**1 Products affected**

**2 Type of change**

V-Lock cord retaining feature as standard.

CD Power Entry Module with Filter					0118.2258	
creation date	created by	release date	released by	notification no.	revision	page
2015-01-14	hollenpe	2015-06-08	hollenpe	26910	-	1 of 2

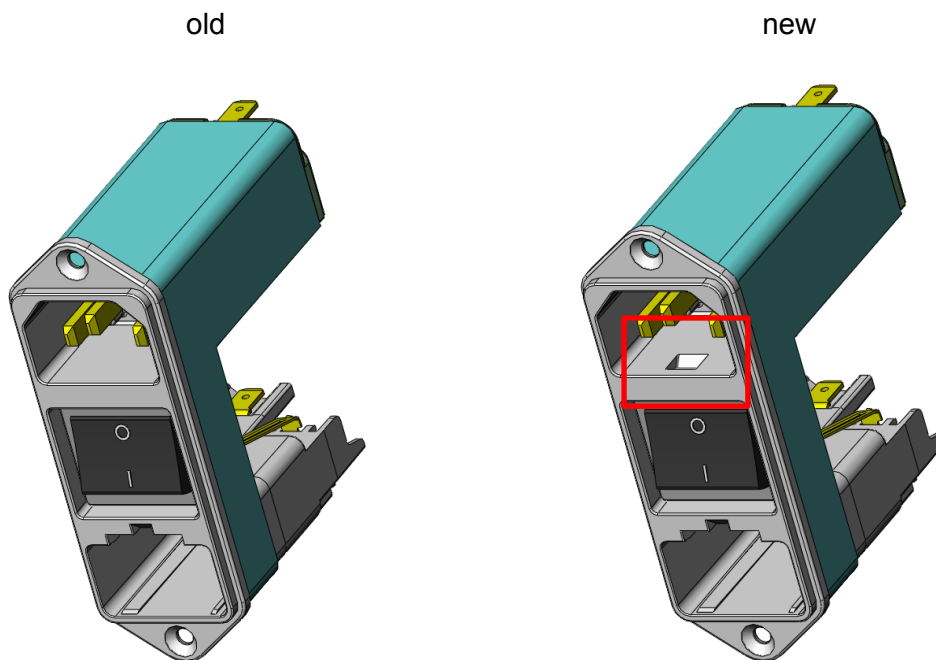
V-Lock feature integrated as standard (not an option anymore)

Form: Yes C14 inlet with V-Lock notch as standard  
 Fit: No There are no dimensional changes  
 Function: Yes V-Lock feature is standard (not an option anymore)  
 Production Site: No There are no change of the production site  
 Product Label: No No change of the product label

As the V-Lock is now a standard feature, the material numbers with index .21 are obsolete and will be replaced by the standard number:

CD61.1501.151.21 → CD61.1501.151  
 CD64.1101.151.21 → CD64.1101.151  
 CDC4.4101.151.21 → CDC4.4101.151  
 CDE4.4101.151.21 → CDE4.4101.151  
 CDM4.4101.151.21 → CDM4.4101.151
